# Groundwater Transfer Review Summary Form

Transfer/PA # T- 14616 (RA)

Application: T-14616

Applicant Name: Peterson Farm Land Holdings LLC

# T14616 Peterson Farm Land Holdings LLC

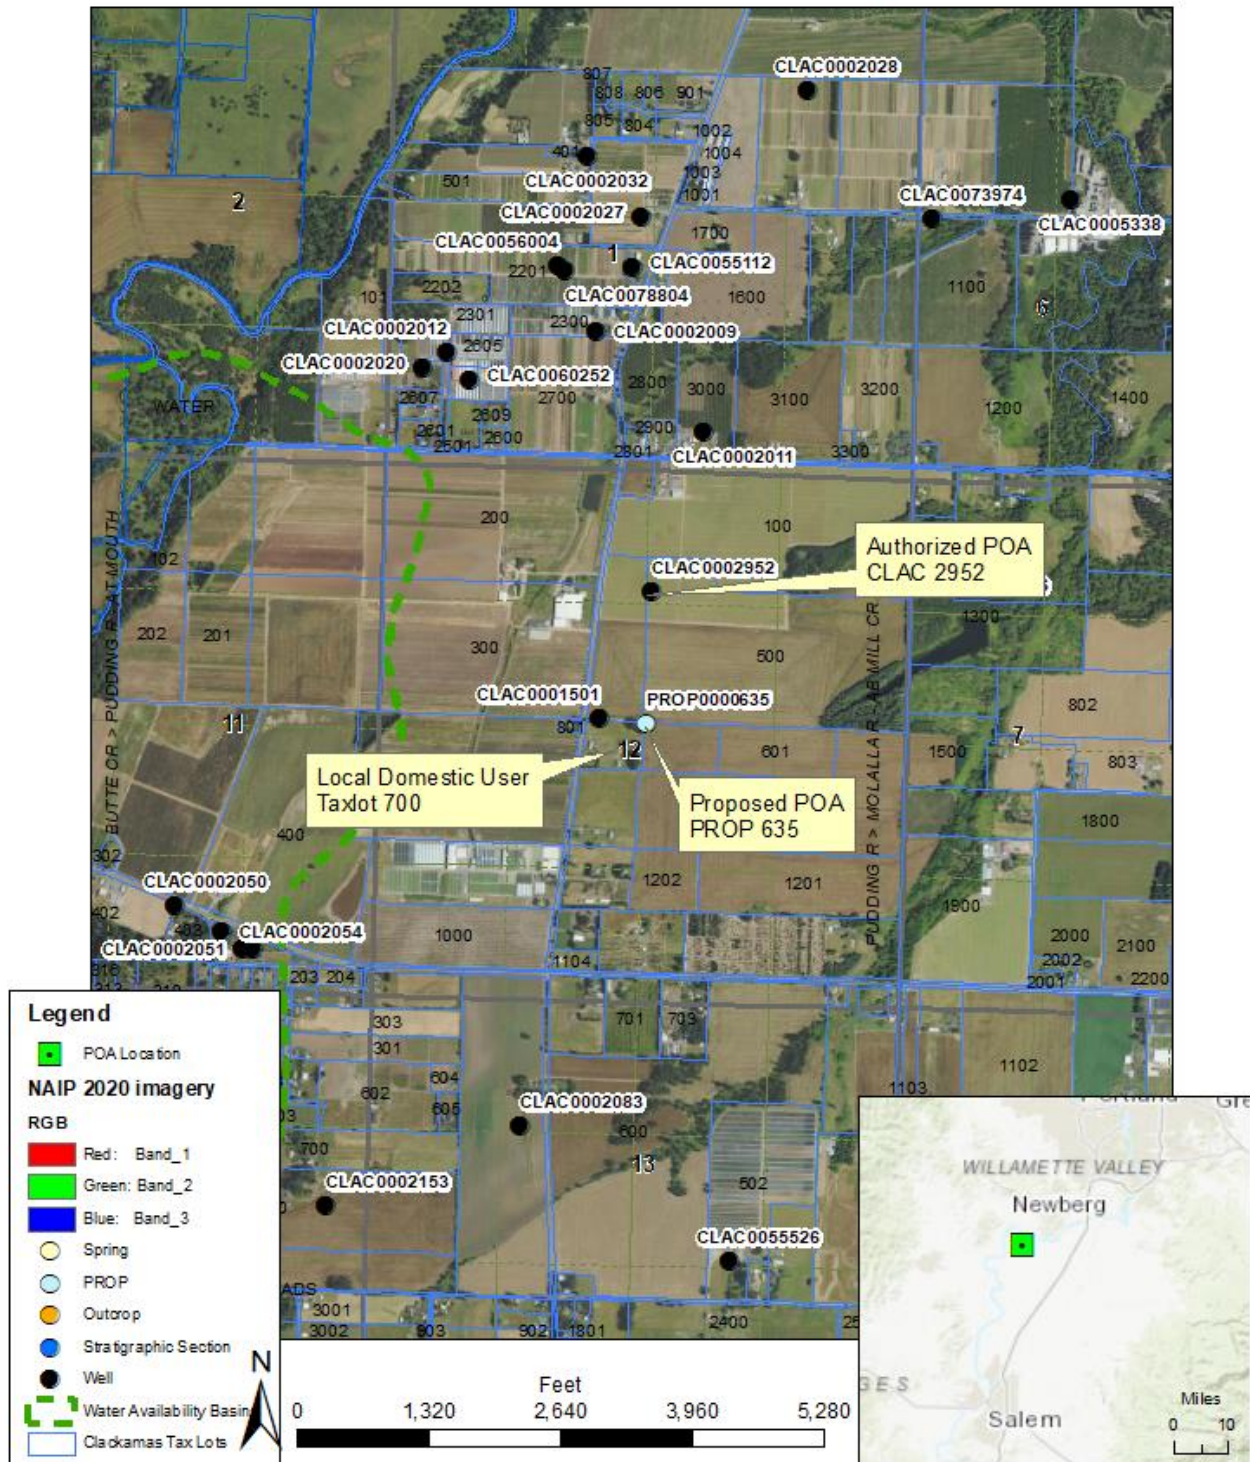
☒ Yes   ☐ No   Comments: The proposed POA is approximately 1000 feet closer to nearby wells than the authorized POA. Therefore 0.76 cfs of the original pumping would be closer to the nearby wells. When combined with the remainder of the pumping (0.46 cfs) at the authorized POA (Well 1), it is likely that there would be an increase in interference with the nearby wells.

The closest nearby water right is the domestic well serving Tax Lot 700 (unidentifiable at the time of this review). The proposed POA (Proposed Well 2, PROP 635) is approximately 375 feet away from the center of Tax Lot 700 and the authorized POA is approximately 1530 feet away. CLAC 1501, also nearby, is not an authorized POA or exempt well; it was on Permit G-11369 which preceded Certificate 87542, but was replaced by CLAC 2952 - Well 1 in this transfer.
